Re: Simms Federal #1 Water Disposal Well
NW SE Sec.13, T30N, R4W
East Blanco Field
Rio Arriba County, NM

Re: Simms Federal No. 1 &
Administrative Order SWD-665

Mallon Oil Company is requesting an amendment to Administrative Order SWD-665 approved by your office on May 28, 1998. This approved administrative order SWD-665 was then amended to include injection into the Morrison and Entrada Formations from 8,600' – 9,570'. The amendment also included approval to inject 100 MCF per day of hydrogen sulfide gas into the Simms Federal #1 well. The amendment was approved on June 28, 1998 (See Exhibit #1, Amended Administrative Order SWD-665).

**Mallon Oil Company
Well Workover Procedure**

Proposed Wellbore Diagram w/ Tie-Back Liner

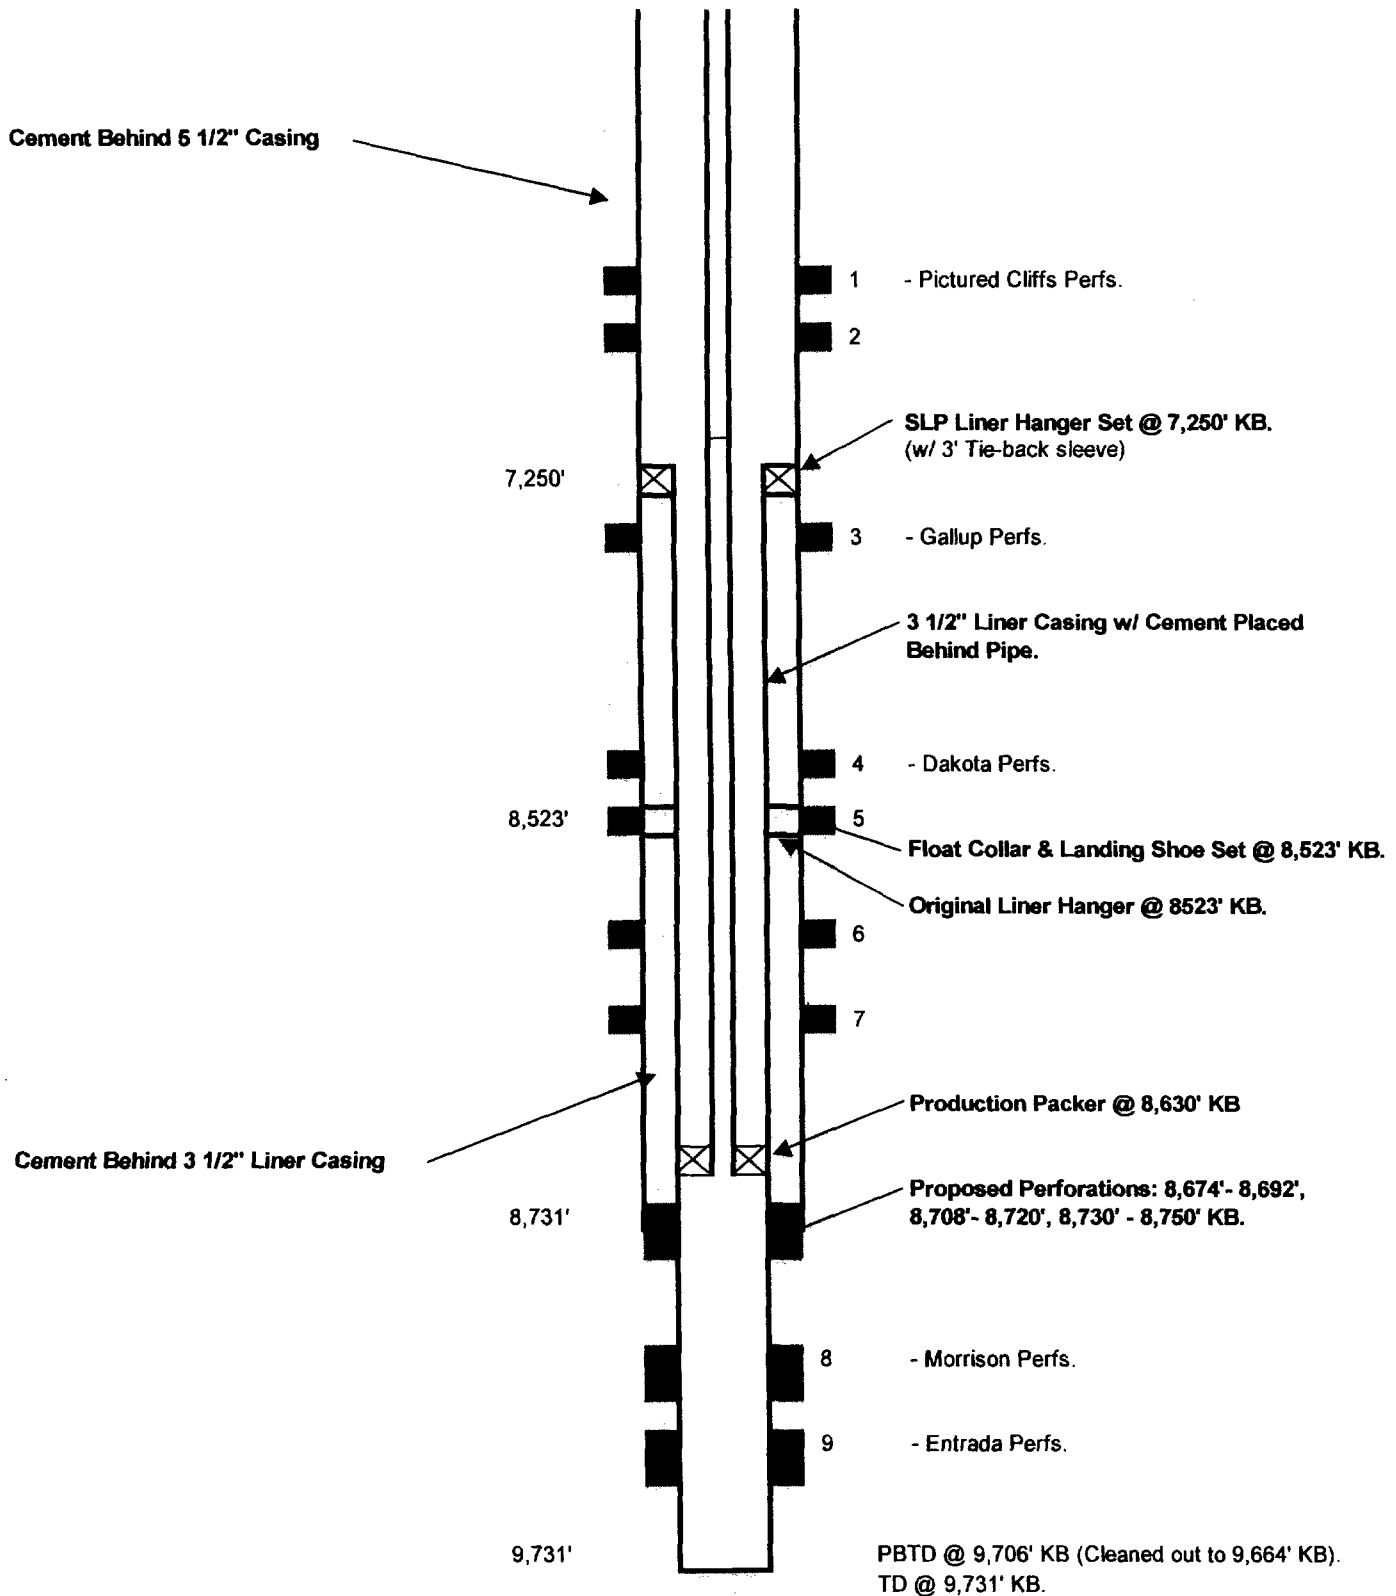
At this time Mallon Oil is proposing to workover the Simms Federal #1 to repair a possible casing leak, run new Duoline-20 fiberglass lined tubing, and add perforations to the permitted Morrison interval (See Exhibit #2, Workover procedure, logs of proposed perforation intervals, and sundry notice). However, it has been brought to our attention by Steve Hayden (Geologist with the New Mexico OCD, Aztec office) that our proposed perforation interval (8,674' – 8,750' gross) actually falls within the Burro Canyon Formation. The original picked top of the Morrison Formation at 8,600' is incorrect according to Steve and includes a portion of the Burro Canyon. In accordance with Steve's request, Mallon Oil is requesting that the approved administrative order SWD-665 be amended to allow injection in the Burro Canyon. The permitted interval will not change, just the nomenclature. We have received verbal approval from the New Mexico OCD (Aztec office) to perforate the additional intervals during the proposed workover. Please contact Steve Hayden or Charlie Perrin if you have any questions or concerns.

Mallon Oil Company is proposing to workover this well to repair a slight casing leak and to install a lined tubing string. The last MIT performed in August 2000 passed with 9.5% pressure loss, indicating a slight casing leak. Mallon Oil Company is proposing to pull the existing injection tubing and packer, isolate the potential leak or leaks using a retrievable bridge plug and packer, and then cement squeeze accordingly to repair the leak and return casing integrity. If wellbore conditions dictate, Mallon Oil Company will run a tie-back 3-1/2" casing liner from the existing liner top at 8523' to a point above the problem area and cement the liner in place. Mallon Oil Company is also requesting approval to perforate additional zones within the approved injection interval to ensure future injectivity. The proposed perforation intervals are at 8,674'-8,692', 8,708'-8,720' and 8,730'-8,750' KB with 2 SPF. Please refer to the attached workover procedure, electric logs, and wellbore diagram. Mallon Oil Company is proposing to start this workover on Monday, June 4, 2001.

Project: Install fiberglass lined tubing as per the New Mexico OCD. Pressure test casing for leaks and cement squeeze according. If well conditions dictate, install a 3 1/2" tie-back liner up over the problem interval and cement in place. Also, perforate additional zones for injection. Last MIT 8/24/00 (P @ 369 psig, lost 34 psig in 30 minutes, 9.48% loss).

0 3	GAMMA RAY API COUNTS CALIPER INCHES	200 130	Sec 13 ACTUAL AR	T30N, R4W	NEU PORO	
			BOR HOLE		DEH PORO	
			E240 FT	Spectral Density 2/12/98	25 T2000	DEH CORR GM/CC TENSION POUNDS

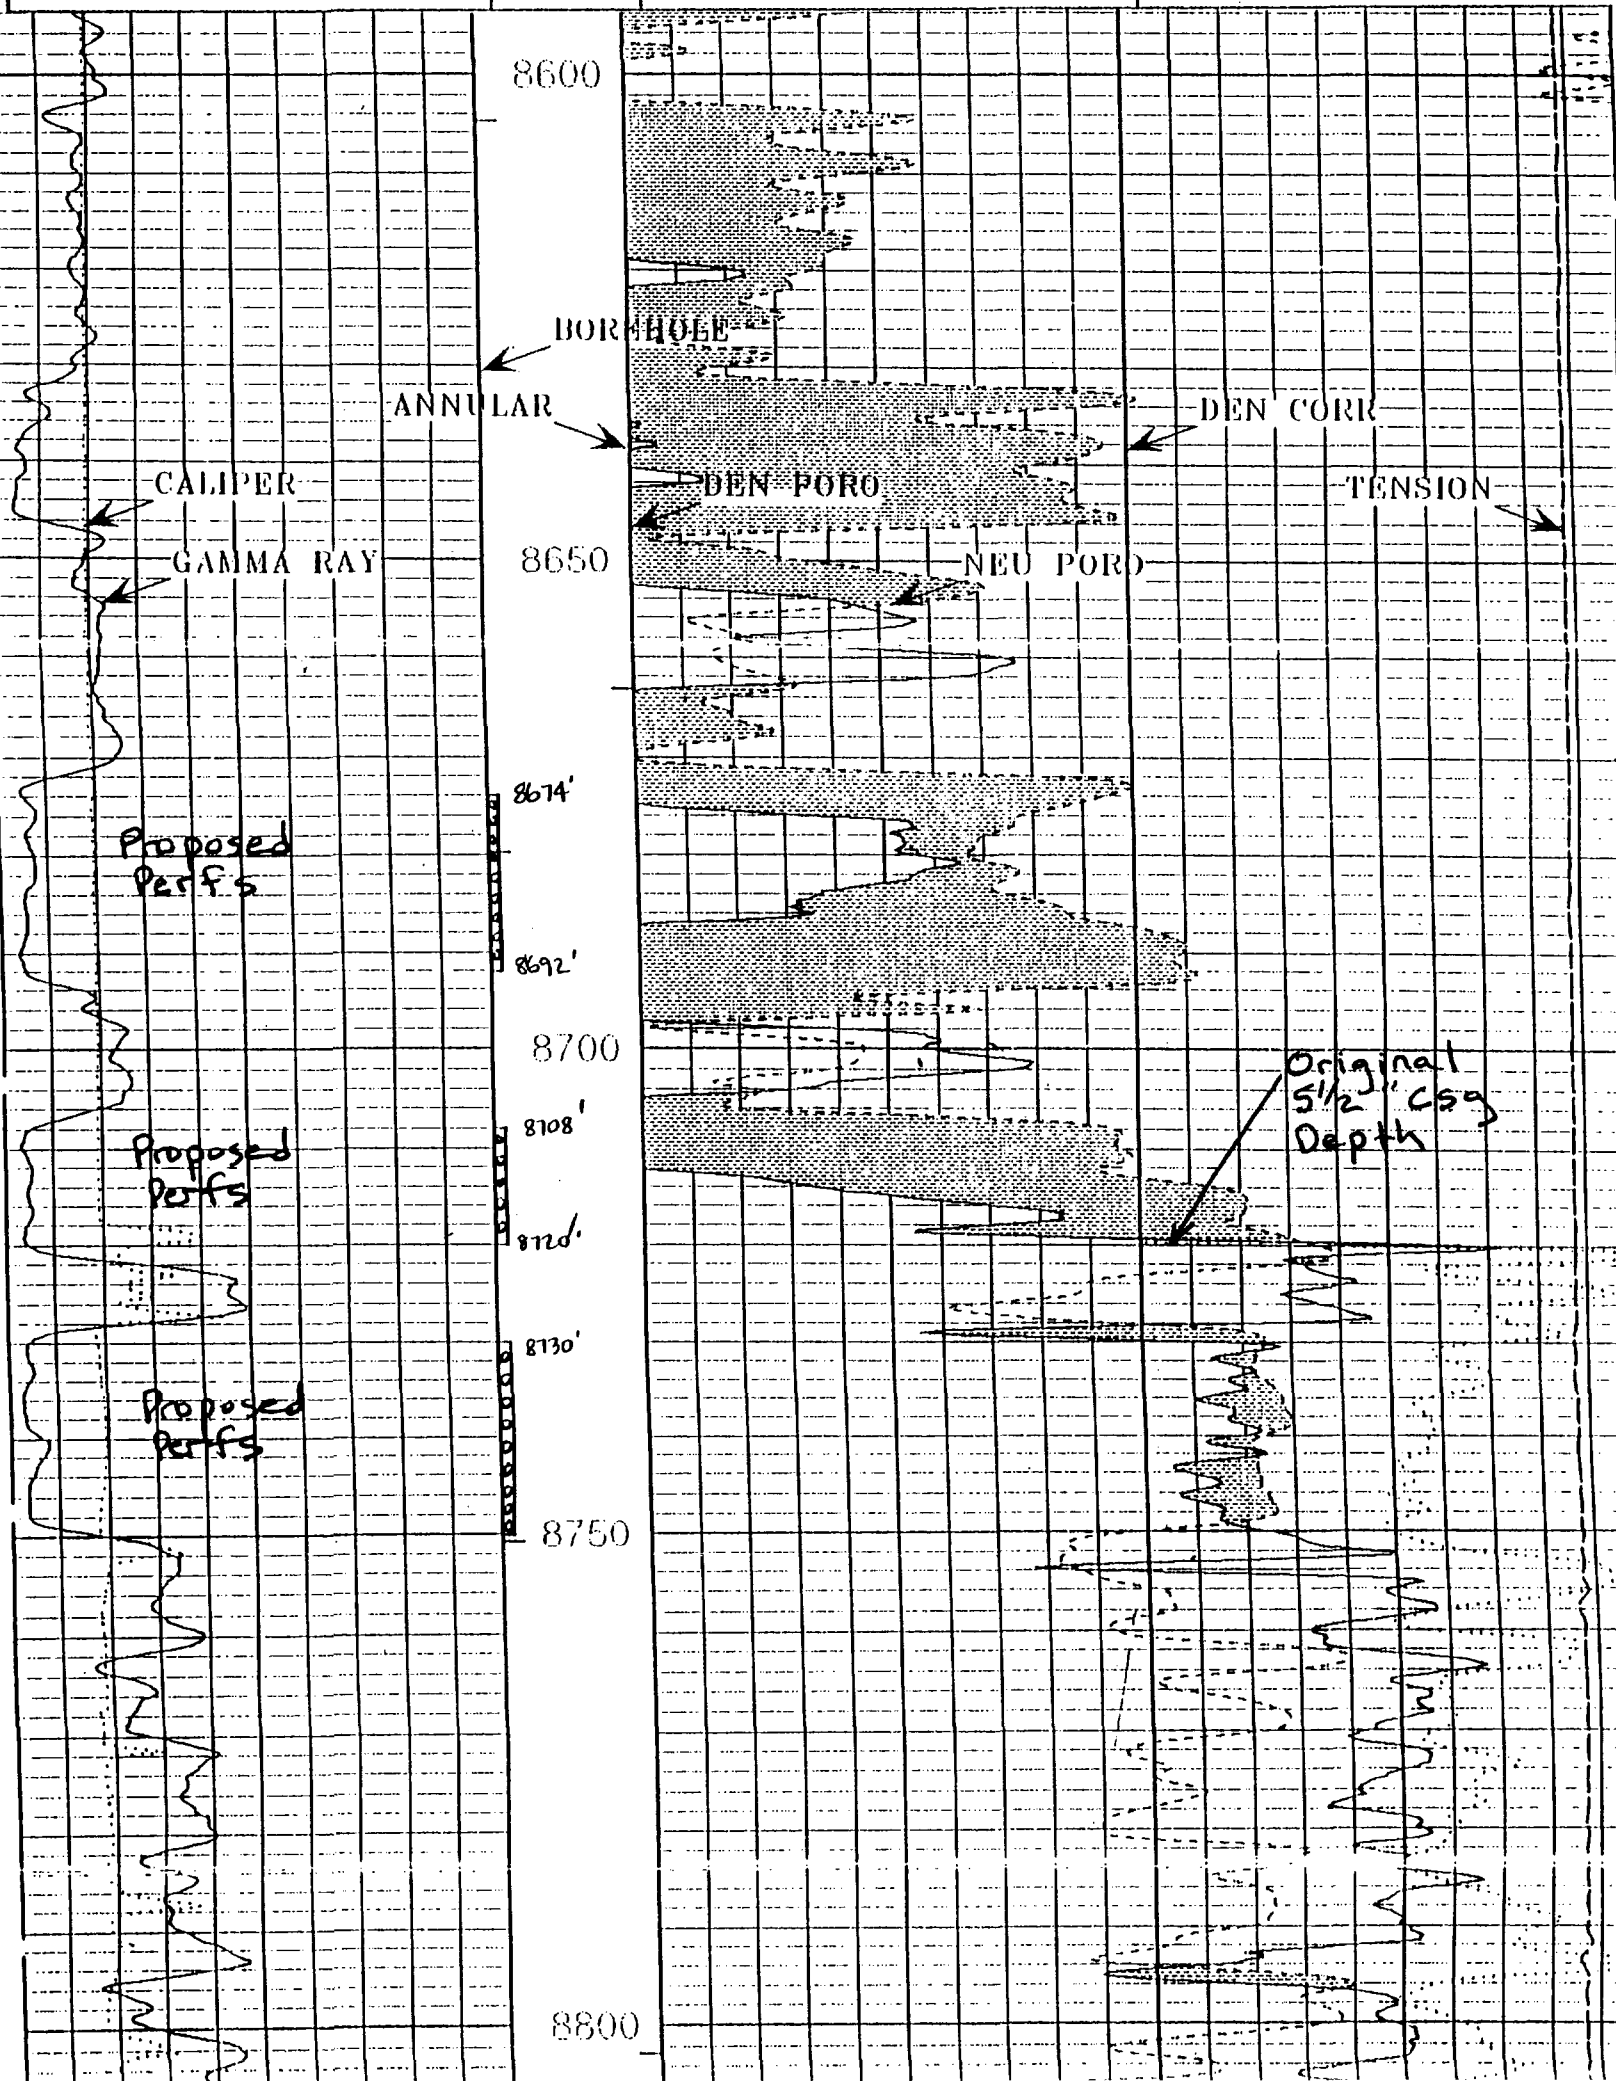
- 7) RU perforators, RIH w/ carrier gun & perforate from 8,974' - 8,692', 8,708' - 8,720', & 8,730' - 8,750' KB w/ 2 spf, 120 degree phasing.
Note: Use Spectral Density Log dated 2/12/98 for perforation correlation.

In accordance with your conditions of approval for the proposed workover on the Simms Federal #1 SWD well, I have received verbal approval from David Catanach with the Santa Fe OCD office to perforate the proposed interval (8,674' – 8,750' gross) which falls within the Burro Canyon Formation. The original picked top of the Morrison Formation at 8,600' is incorrect according to Steve Hayden and includes a portion of the Burro Canyon. In accordance with Steve's request, David Catanach will amend the administrative order SWD-665 to allow water injection in the Burro Canyon. The permitted interval will not change, just the nomenclature.
